PERMIT
ON-SITE SEWAGE DISPOSAL SYSTEM
HOWARD COUNTY HEALTH DEPARTMENT
BUREAU OF ENVIRONMENTAL HEALTH

SUBDIVISION: Clarksville Overlook LOT NUMBER: 9

ADDRESS: 12848 Macbeth Farm Lane PROPERTY OWNER: NV Homes

SEPTIC SPECIFICATIONS WORKSHEET

NOT TO SCALE

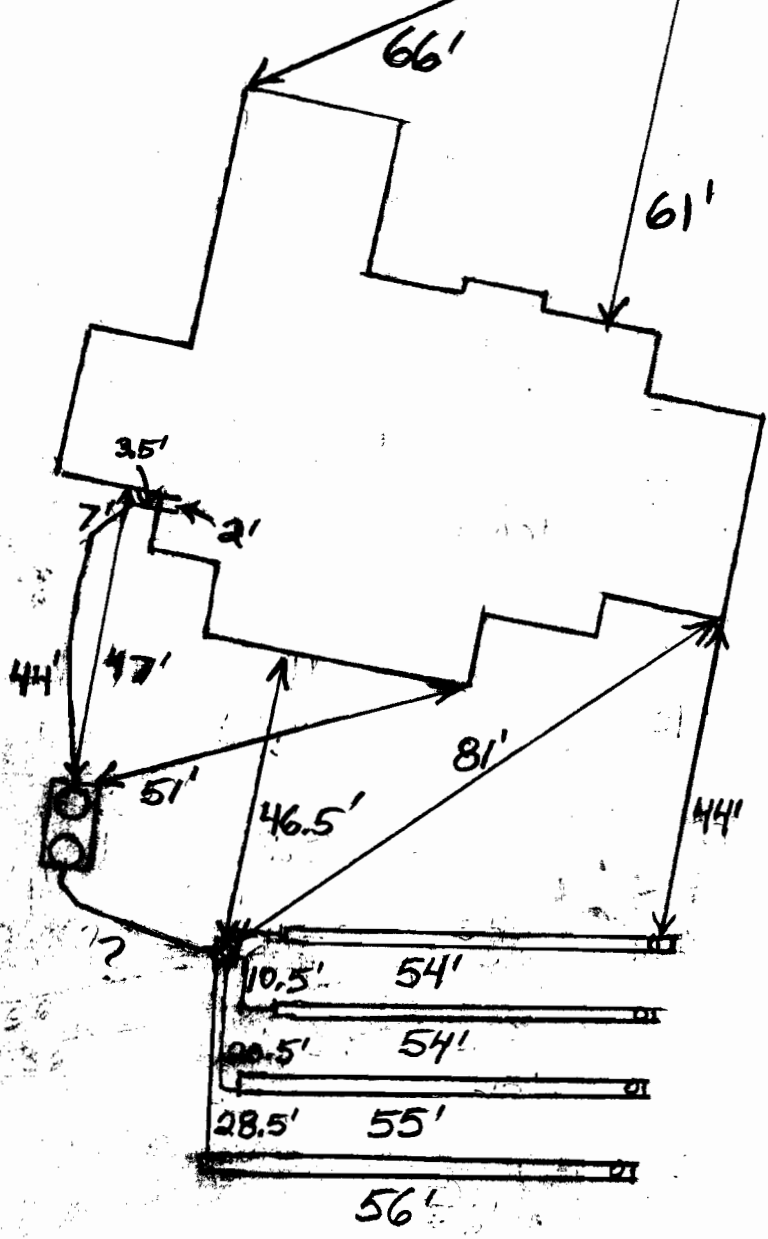
PRE-CONSTRUCTION
 11/16/07 Set the distribution box in the top middle of the easement and

install 2-56' trenches towards both sides of the easement. Set tank out of the way of future deck. 11/26/07
 INSTALLATION: System finished. Trenches not installed per layout but should be O.K. (BB)
